Installation of New ALPS Treated Water Dilution/Discharge Facilities and the Related Facility

20th January, 2022

Responses to major issues^(*) concerning the content of the application for the Discharge Facilities of the ALPS treated water into the Sea

*Document 1-2 for (The 3rd) Review Meeting on the Implementation Plan Regarding the Handling of ALPS Treated Water

[Supplement] Principle for designing ALPS Treated Water transfer pumps

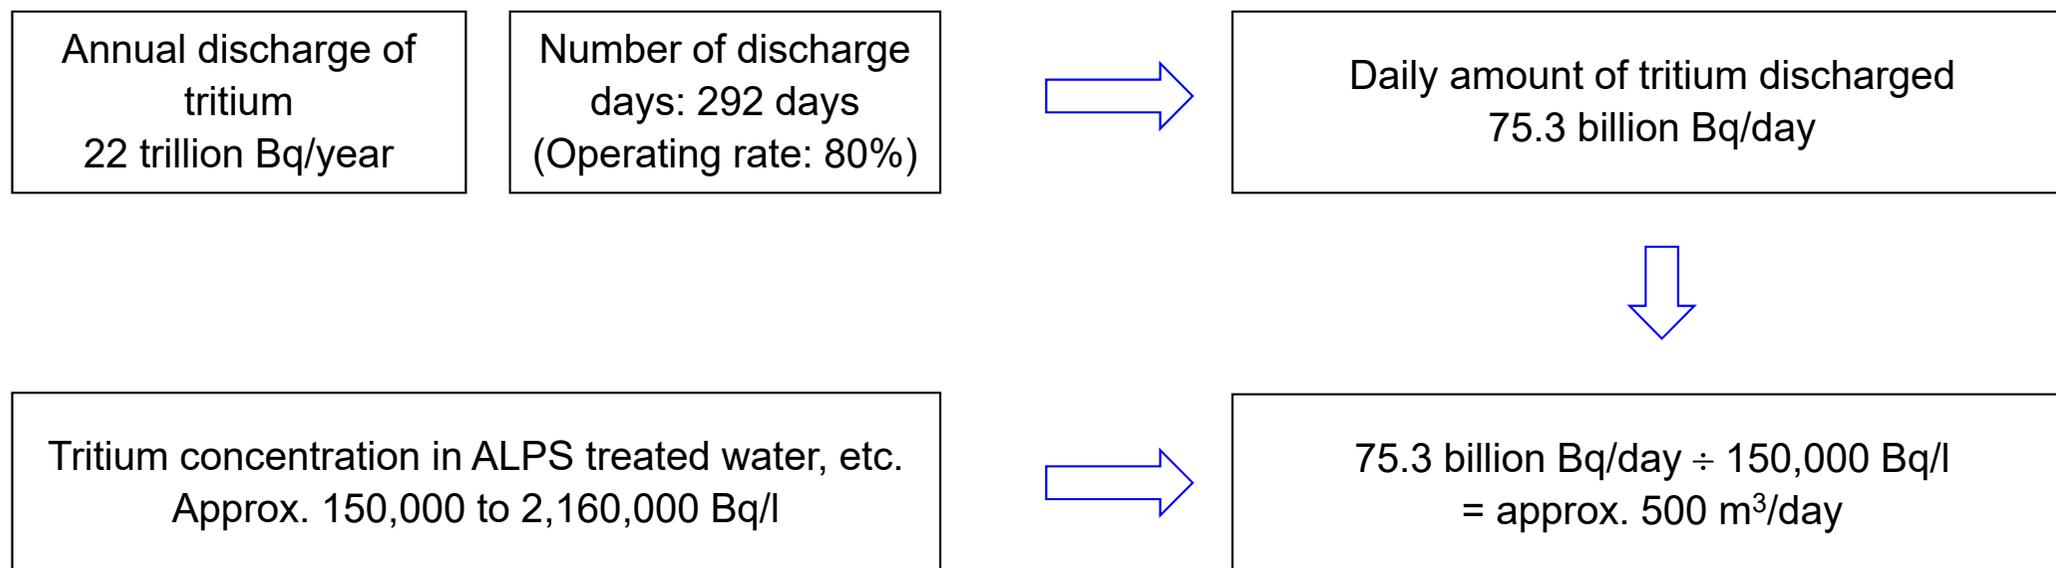
- At present, the tritium concentration in ALPS Treated Water stored on the premises of the Fukushima Daiichi NPS varies depending on the period stored in tanks (see the figure below). Since ALPS Treated Water in any tank contains tritium higher than the regulatory concentration limit of 60,000 Bq/l, the ALPS Treated Water requires the dilution with seawater before discharging into the sea.
- For this purpose, toward the ocean discharge of ALPS Treated Water, the capacities of each pump was set under the principle for designing each type of pumps, and summarized in the table below.

- The tritium concentration in the ALPS treated water, etc., stored on the premises of the Fukushima Daiichi NPS ranges from about 150,000 to 2,160,000 Bq/l, averaging about 620,000 Bq/l (estimated value as of April 1, 2021).
- The amount of the ALPS treated water to be transferred is set based on the amount of Annual discharge of tritium, while taking into account the number of days of discharge in consideration of facility maintenance and system switching, and the tritium concentration in ALPS Treated Water to be discharged.
- When the tritium concentration in ALPS Treated Water to be discharged is low, approximately 150,000 Bq/l, the flow rate of the ALPS treated water will be the maximum **approximately 500 m³/day.**

(4) How to mix and dilute ALPS Treated Water with seawater (1/4)

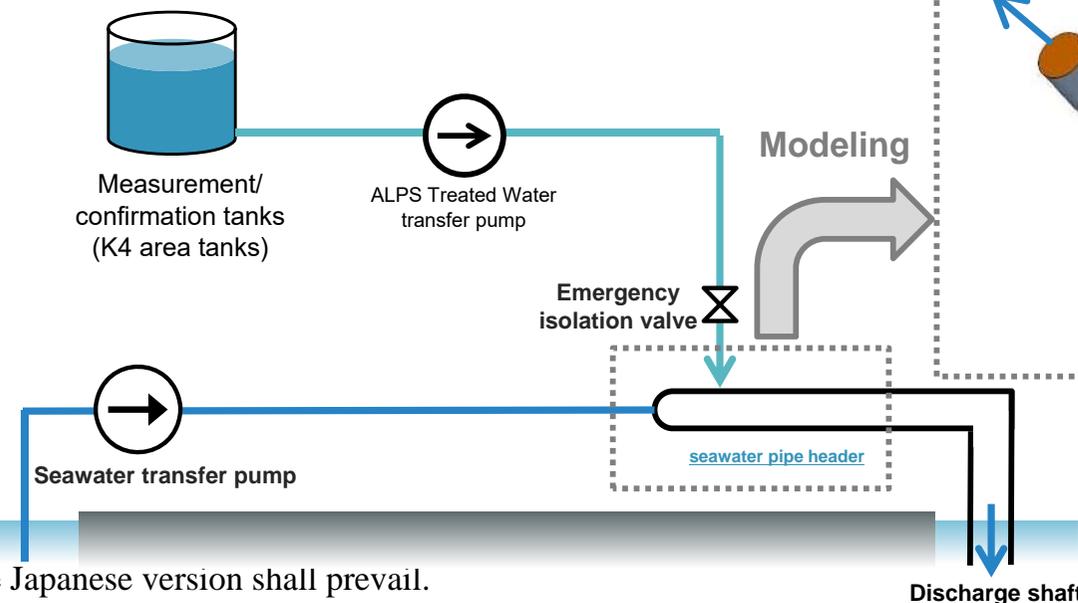
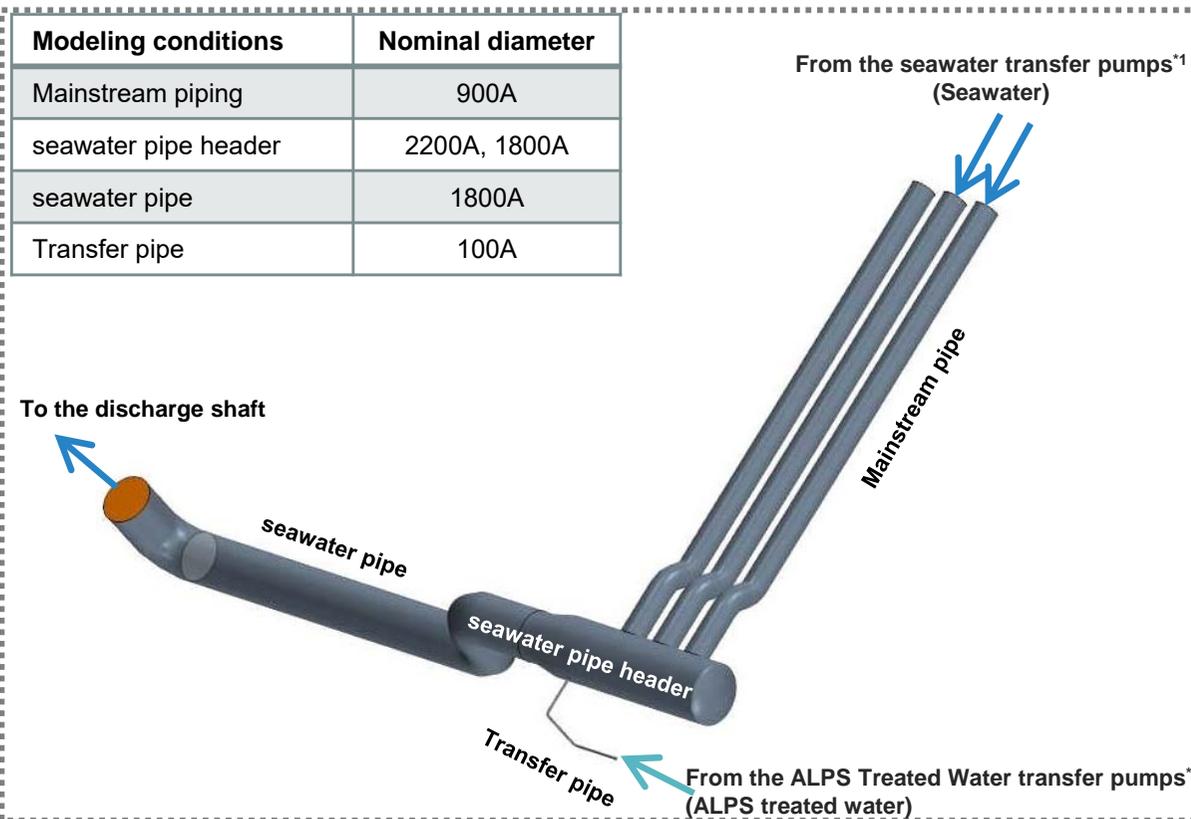
- To mix and dilute ALPS Treated Water with seawater, the treated water is injected into the seawater pipe header through which diluted seawater is running. The ALPS Treated Water injected into the seawater pipe header flows down through the seawater pipe and is mixed with surrounding seawater to reduce the concentration of radioactive materials.
- In order to check the dilution and mixing condition of the ALPS treated water in the seawater pipe, the effect of dilution was estimated by performing a simulation with the numerical values shown below.
- Upon completion of the facility installation, a verification test using a tracer for filtered water will be conducted.

→ This tool is widely used in energy, automobile, and other industrial fields. TEPCO has also used it for thermal analysis and sloshing evaluation for the PCV pressure relief device of unit 7 at the Kashiwazaki-Kariwa NPS.

- *1: Operated with two seawater pumps (170,000 m³/day/unit)
(The pipes marked with arrows are operated)
- *2: Operated at the maximum flow rate of 500 m³/day

Result of the dispersion and mixing analysis of the ALPS treated water in the seawater pipe when dilution is simulated with an ALPS Treated Water flow rate of 500 m³/day and seawater flow rate of 340,000 m³/day

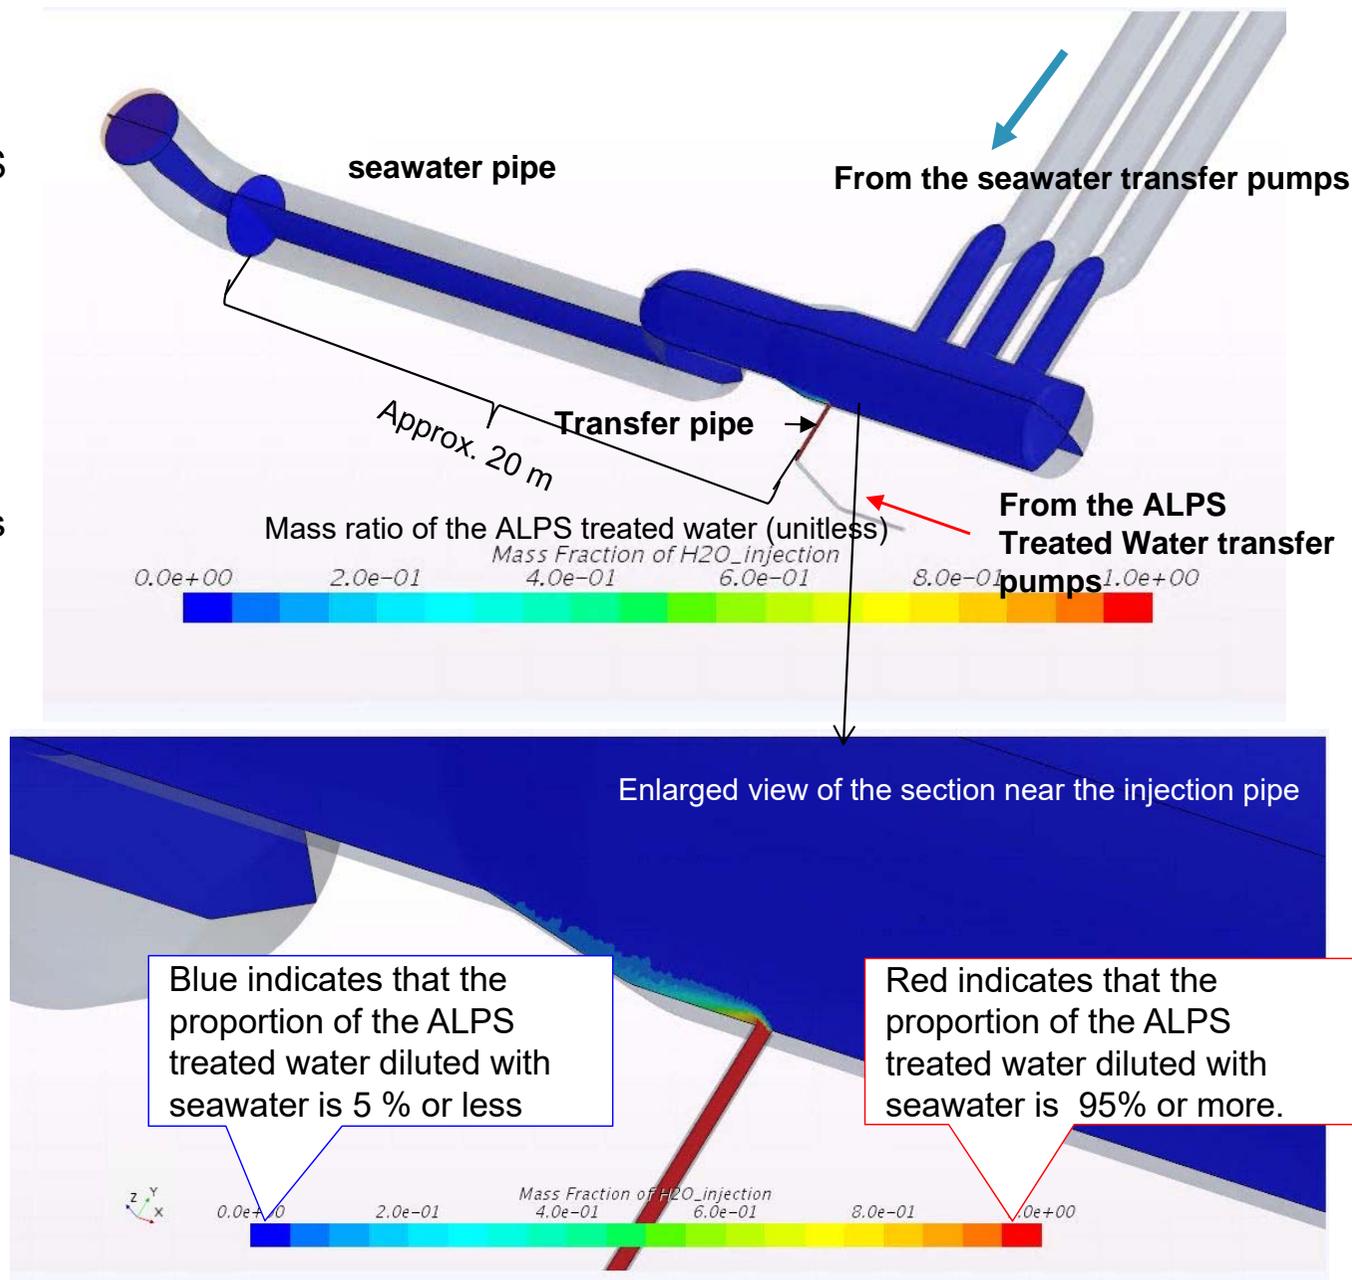
(4) How to mix and dilute the ALPS Treated Water with seawater (2/4)

Confirmed that the ALPS Treated Water was diluted to 5% or less (1/20 or less) in the vicinity of the Transfer pipe.

The figure on the right cannot show detailed dispersion behavior of the dilution rate of 5% or less. Therefore, the result expressed using the logarithmic scale is posted on the next slide.

(4) How to mix and dilute ALPS Treated Water with seawater (3/4)

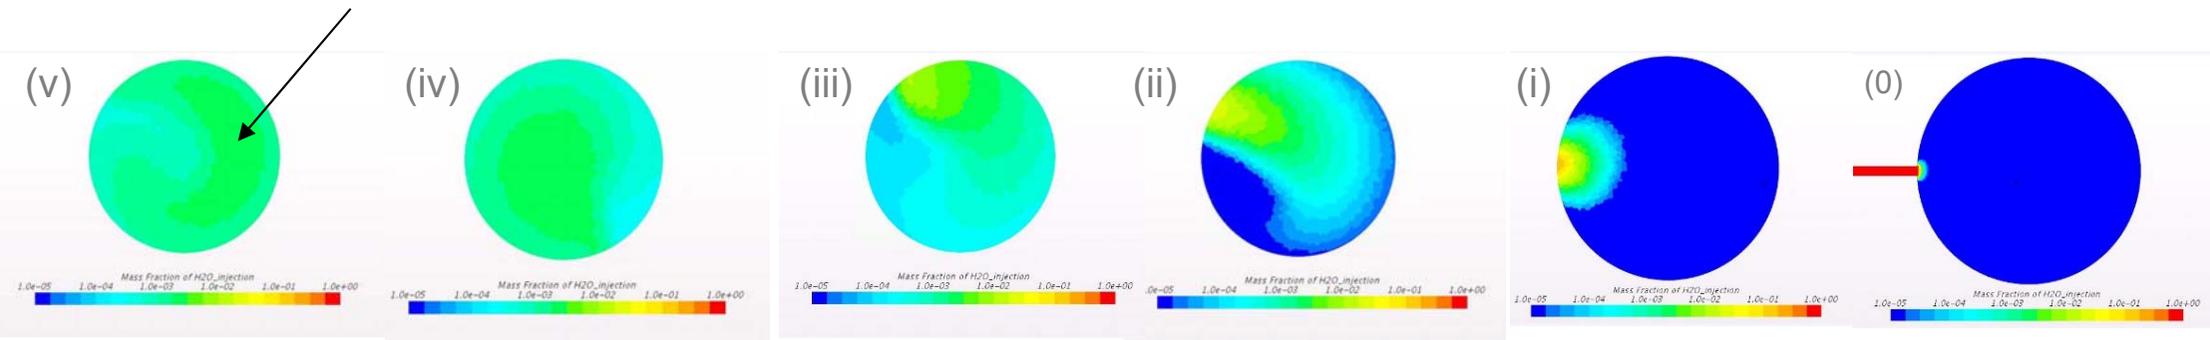
Reference:
Converting mass ratio to volume ratio

The mass ratio of the ALPS treated water is **up to 0.23% (approx. 1/430)**, and diluted to an average of 0.14% (approx. 1/710). When ALPS Treated Water of 150,000 Bq/l is discharged, the concentration becomes approximately 350 Bq/l at the maximum and approximately 220 Bq/l on average. (The average concentration is almost equal to the calculated tritium concentration after dilution with seawater)

Maximum mass concentration of the ALPS treated water at each section
(Graph: Linear scale)

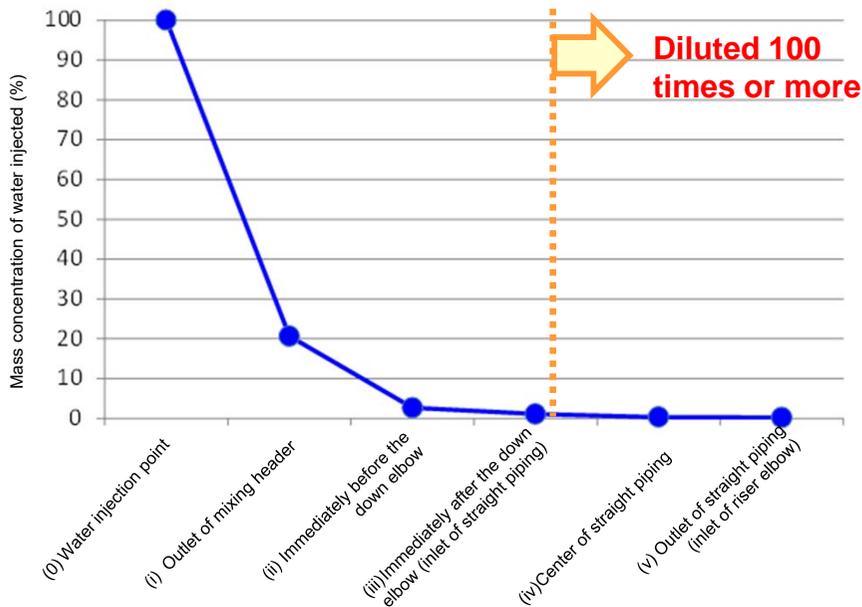
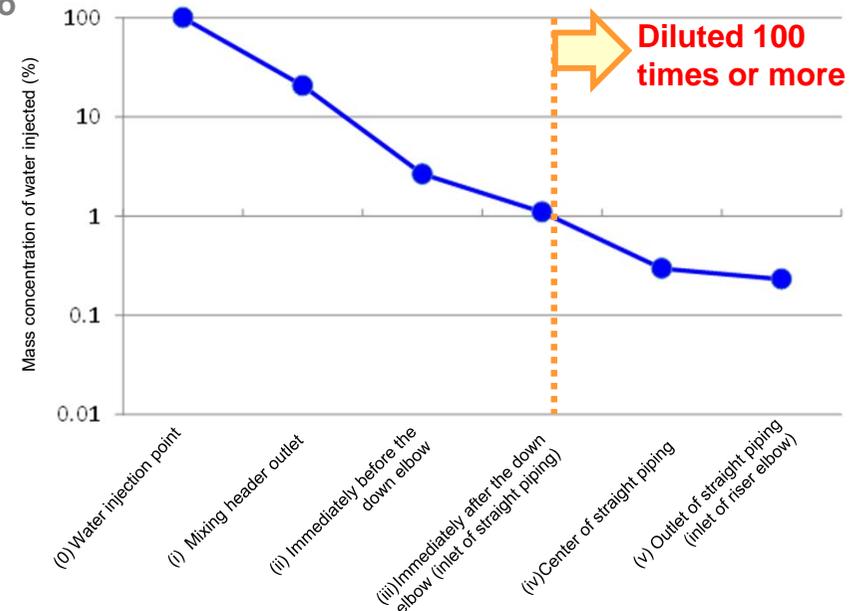
- The figures below show the detailed result of the dilution and mixing condition of the ALPS treated water with seawater in seawater pipe.
- This result shows that a dilution effect of 100 times or more is achieved “(3) immediately after the down elbow (inlet of straight piping)”.

Maximum mass concentration of the ALPS treated water at each section
(Graph: Logarithmic scale)
